[JUNE, 1901]

Dear Miss Morgan,

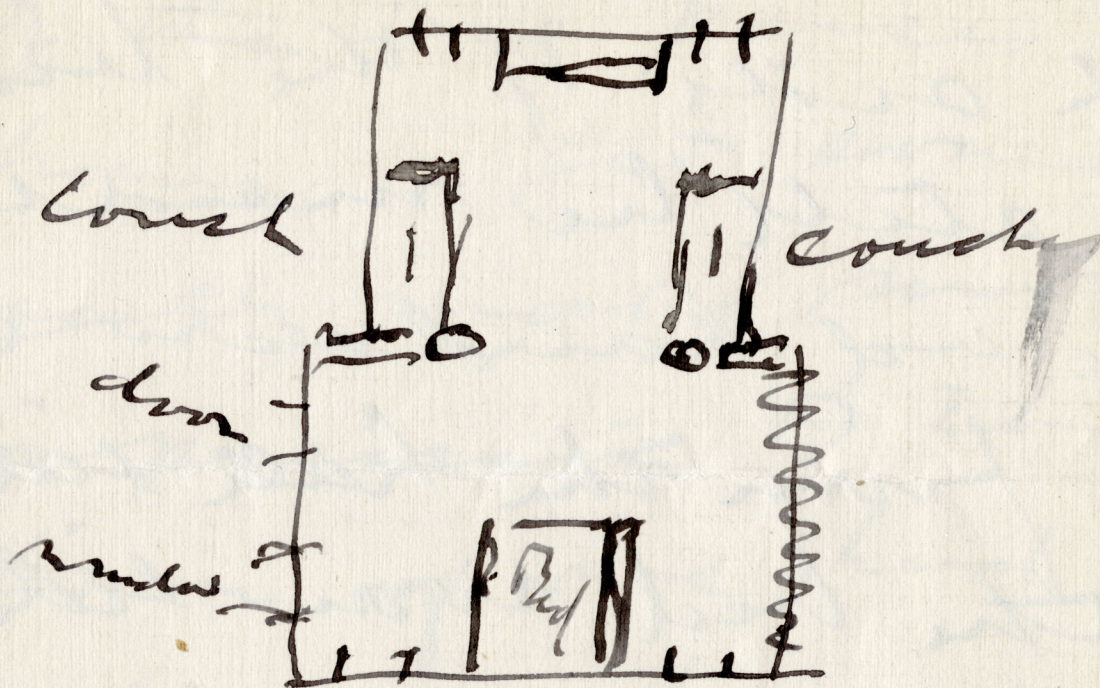
I don't like the plan for the lower floor bed rooms of ^A that I sent you. It is unbalanced. It requires small beds, which we haven't got and it doesn't allow for comfortable furniture.

I am enclosing another plan which is much better in these respects although it loses a little

of the hull treatment
that we have considered
here is the plan.

It sacrifices the big central
door at the entrance and
puts the bed in its place.
This allows the Taperly
to be heavy. It makes
the alcove a fireplace alcove
with big couches on either

side which is nice
and comfortable.

I think the doors on
each side of the bed
can still be made
large and handsome
both from the hall side
and the bed room side

We can use the
fine big beds and
get good effects all
around.

In the hall or lobby
we will have to have

effective furnishings
between the doors but
we can use some
of the big pieces we
have or get some and
really make more
impression I think
than if we had left
only one door in the
middle.
